BULLETIN (REVISION B)

DATE:	May 01, 2000	# of Pages: 4
REFERENCE:	SERVICE BULLETIN # SPSB: 03032000 – Revision B	
SUBJECT:	MAIN CLOSING LOOP RETAINER – Grommet Protection	
STATUS:	MANDATORY for Javelin's manufactured prior to September 1993, RECOMMENDED for Javelin's manufactured September 1993 up to and including March 2000.

FIGURE 1

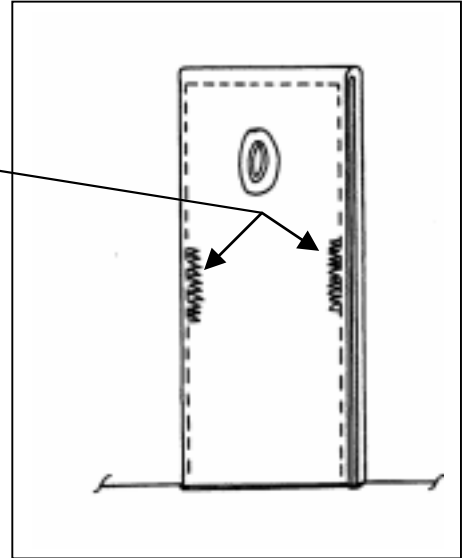
1. Unpick and remove bartacks carefully. [Fig 1].

FIGURE 2

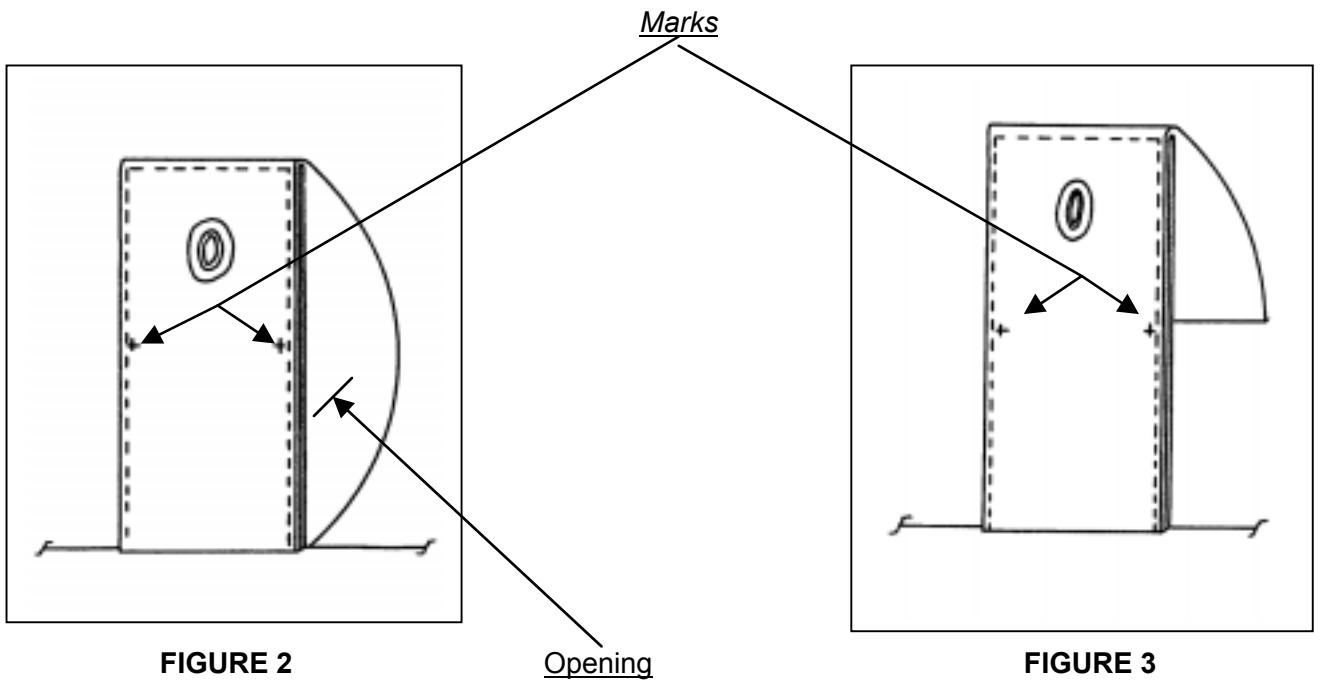
2. You should have a continuous loop of Type 12. [Fig 2].
3. Some older rigs had a short cover behind the grommet [Fig 3]. Follow the instructions below ignoring the references to the continuous loop in the diagrams. Your end result will be the covering of the grommet and final bartacking of the short cover in place. [Fig 6].

Mark closing loop retainer at midpoint of removed bartacks with marker pencil.

- Cut Type 12 webbing at 6" (165mm) for short closing loop retainers (most Javelins) or, 10" (260mm) for long closing loop retainers found on J6N, J7N, J10 and J12's.

Line up hot-knifed edge of Type 12 webbing at marks as marked in Fig 2 & 3.

Lay Type 12 towards grommet and fold it so that the fold lines up with the top of the grommet.

Mark the top layer of Type 12 directly above the two marks as marked in Fig 2 & 3.

Using a straight stitch machine sew along the edge of the tape from a mid-bartack mark up to and one stitch over the fold and return to the mark.

Sew only to the layers of Type 12 that the grommet is set through. Do **NOT** sew through the back part of the closing loop retainer. (Continuous loop or short cover).

FIGURE 4

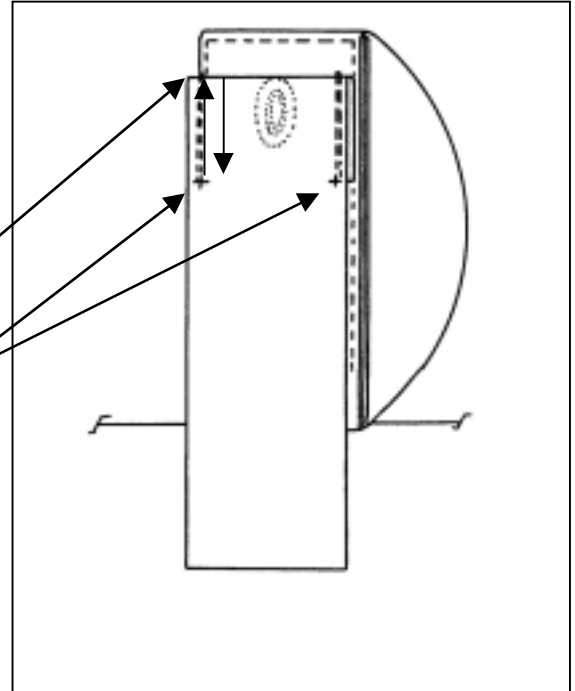
Repeat on other side [Fig 4].

- Lay closing loop retainer flat and fold unsewn piece so that the fold is as close to the reserve container as possible.

Sew around three sides from mark to mark as made in Fig 4.

FIGURE 5

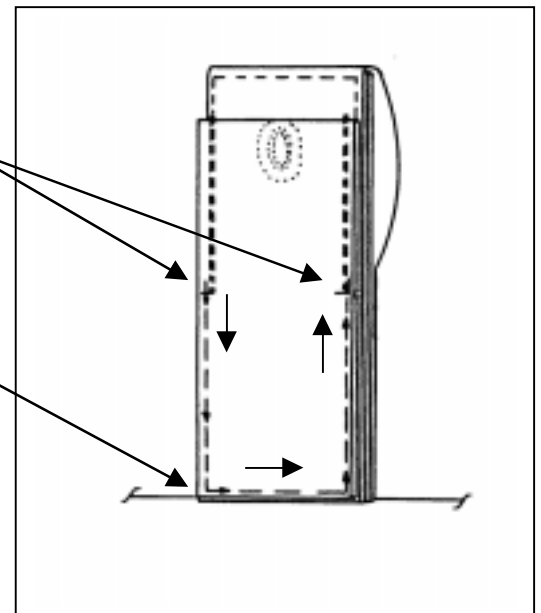
Be careful not to sew closed the opening for the closing loop. [Fig 5].

FIGURE 6

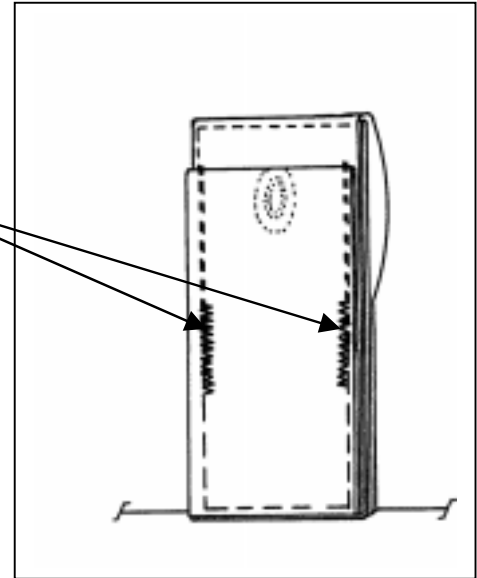
6. Replace bartacks or zig-zag new locking stitches in same place as the ones taken out. [Fig 6].

NOTE: The short cover must be secured in place with the bartacks.

Trim threads and update Packing Data Card with Service Bulletin Compliance.
